**BEFORE HEARING COMMISSIONERS
IN THE WESTERN BAY OF PLENTY DISTRICT**

UNDER THE Resource Management Act 1991 (“**Act**”)
IN THE MATTER OF an application for resource consent to authorise
four existing industrial activities within part of the Te
Puna Business Park structure plan area, for a term
of two years
BETWEEN **TINEX GROUP LIMITED**
Applicant
AND **WESTERN BAY OF BAY OF PLENTY DISTRICT COUNCIL**
Consent authority

REPLY EVIDENCE OF CALUM MCLEAN

Figure 1: Warrant for Right Turn Lane

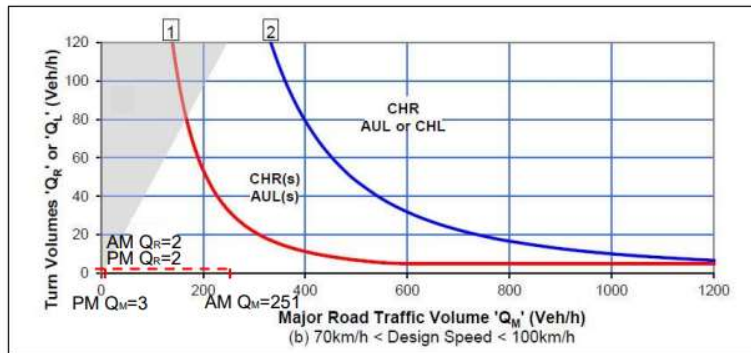
23. I concur with Mr Harrison’s assessment that a Channelised Right (CHR) turn treatment, typically called a right turn bay, or right turn lane, is not warranted but note that the same assessment confirms that a BAR treatment is necessary. See figure 1 of TA Additional Information issued 30 May 2023 reproduced below:

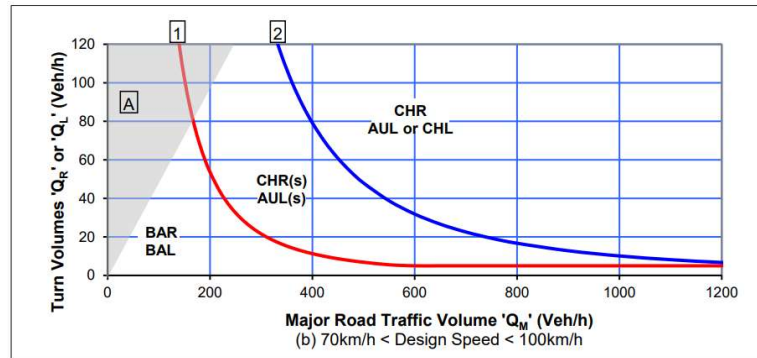
Note: on a two-lane two-way road curve 1 represents the boundary between a BAR and a CHR(S) treatment, as evidenced by AGTM06-20 Figure 3.25 reproduced below:
